**PLANNED UNIT DEVELOPMENT
STAFF REPORT**

Sandefur Properties, LLC

1753 Spring Hill Avenue
(Southwest corner of Spring Hill Avenue and Mobile
Infirmary Boulevard)

Planned Unit Development Approval to amend a previous
Planned Unit Development to allow shared access and
parking between multiple sites.

PROPOSED SITE PLAN

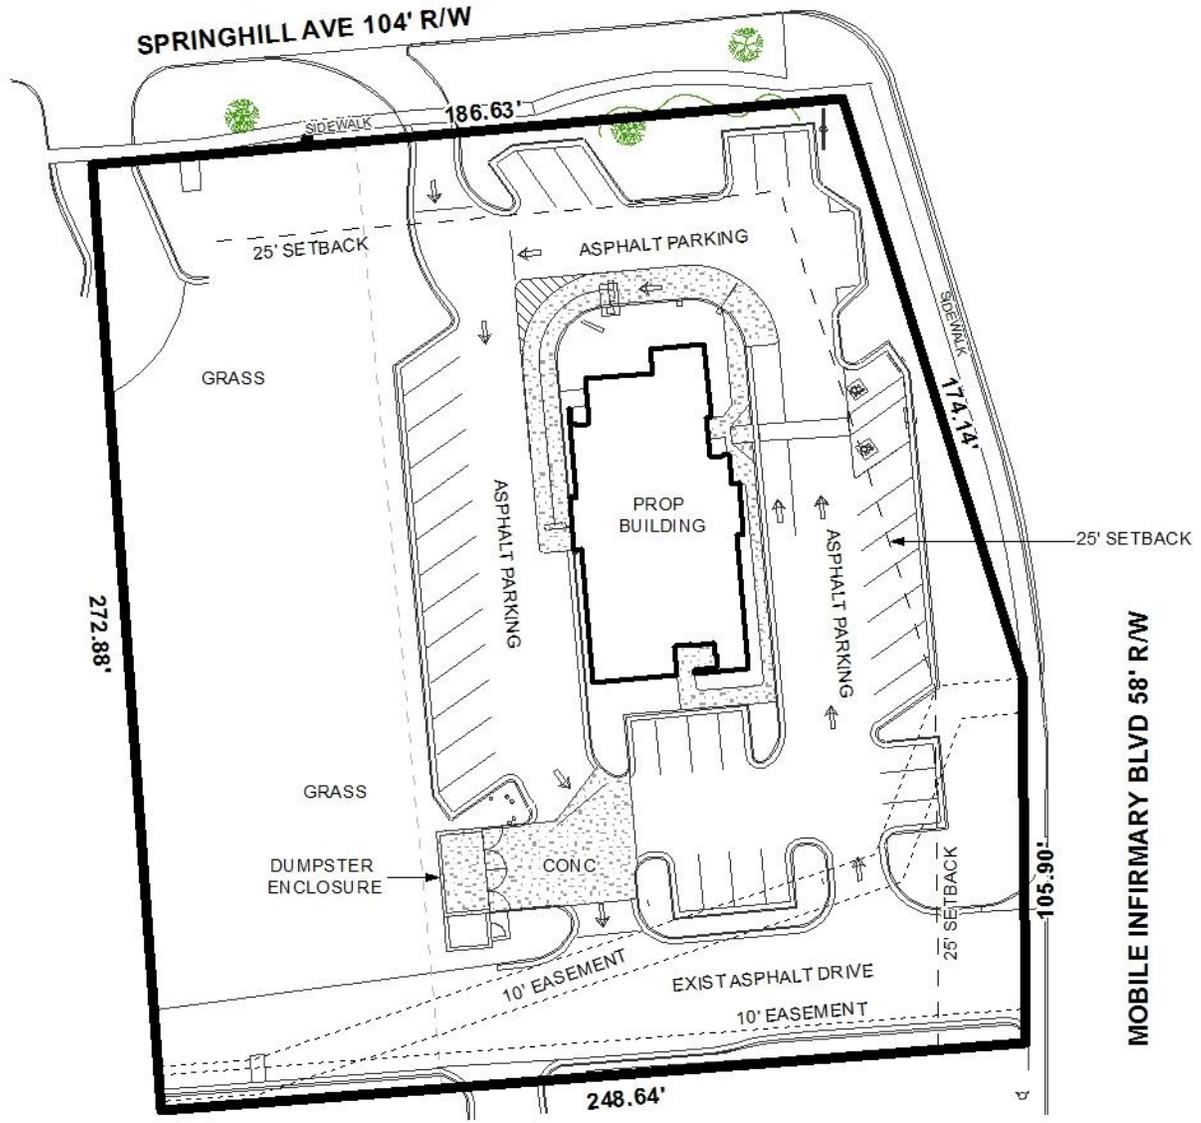
Spring Hill Avenue (US Highway 98) is an ALDOT maintained roadway. Lot 1A and 1B are limited to no more than their existing shared curb cuts on Spring Hill Avenue, with size, location and design to be approved by ALDOT and Traffic Engineering and conform to AASHTO standards. Lot 1A is also limited to one curb cut to Mobile Infirmary Boulevard, with size, location and design to be approved by Traffic Engineering and conform to AASHTO standards. Required on-site parking, including ADA handicap spaces, shall meet the minimum standards as defined in Section 64-6 of the City’s Zoning Ordinance. The proposed striping does not match the International Symbol for Access and should be revised prior to permitting to meet the accepted standard.

The site currently has a structure which the applicant is proposing to demolish and construct a new restaurant. It should be noted that a demolition permit will be required for the existing structure prior to the issuance of building and land disturbance permits. The applicant has revised the proposed site plan from that approved in May to illustrate changes in the parking layout, including the provision of six parking spaces along Spring Hill Avenue that were to be removed from the site as a condition of the approval received in May. No explanation was included with the application regarding the reasons for the proposed change.

The restaurant is illustrated as being 3,652 square feet, requiring 37 parking spaces. The site plan illustrates 40 parking spaces, providing an overage. Curbing is illustrated for all parking spaces to prevent vehicles from parking on the landscaped area.

The site plan illustrates a dumpster on the site, with a note stating to reference a page not provided with this application for details. If approved, the site plan should be revised to specifically state that the dumpster will comply with Section 64-4.D.9. of the Zoning Ordinance.

The site plan illustrates several proposed signs including a freestanding sign, a "welcome" sign, a "thank you" sign, a menu board, and a pre-sell board. It should be noted that as long as the "welcome" and "thank you" signs do not have the name of the business or a logo, they are considered informational and do not require sign permits. All other signs will require a sign permit, however the pre-sell board may not be allowed on the site as one menu board is allowed per drive-thru lane, and the proposed layout of the site only indicates a single drive-thru lane. Also, it appears the proposed "welcome" sign may be located in a drainage easement; no signs are allowed within easements.

It should be noted that a proposed site plan illustrating tree plantings and landscape area was provided, however it does not show the site as being in compliance with Zoning Ordinance requirements. Based on staff calculations, a total of 6 frontage trees are required along Spring Hill Avenue, 9 frontage trees are required along Mobile Infirmary Boulevard, and 2 parking trees are required. The site plan states that there are two existing trees along Spring Hill Avenue to be used as credits for tree planting; however, only one of these trees is located on the subject site and able to be counted as tree credit. Furthermore, the dimensions of the property given in the

landscape calculations do not match what is illustrated on the site plan, and no landscape area information is given in square feet, but the site plan indicates full compliance with landscape area will be provided. If approved, the site plan should be revised to illustrate full compliance with tree planting and landscape area

- 1) obtaining a demolition permit for the existing structure prior to issuance of land disturbance or building permits;
- 2) indicate the dumpster will be connected to sanitary sewer and an enclosure in compliance with Section 64-4.D.9. of the Zoning Ordinance will be provided;

- 4) compliance with Traffic Engineering comments (*Spring Hill Avenue (US Highway 98) is an ALDOT maintained roadway. Lot 1A and 1B are limited to no more than their existing shared curb cuts on Spring Hill Avenue, with size, location and design to be approved by ALDOT and Traffic Engineering and conform to AASHTO standards. Lot 1A is also limited to one curb cut to Mobile Infirmary Boulevard, with size, location and design to be approved by Traffic Engineering and conform to AASHTO standards. Required on-site parking, including ADA handicap spaces, shall meet the minimum standards as defined in Section 64-6 of the City's Zoning Ordinance. The proposed striping does not match the International Symbol for Access and should be revised prior to permitting to meet the accepted standard.*);
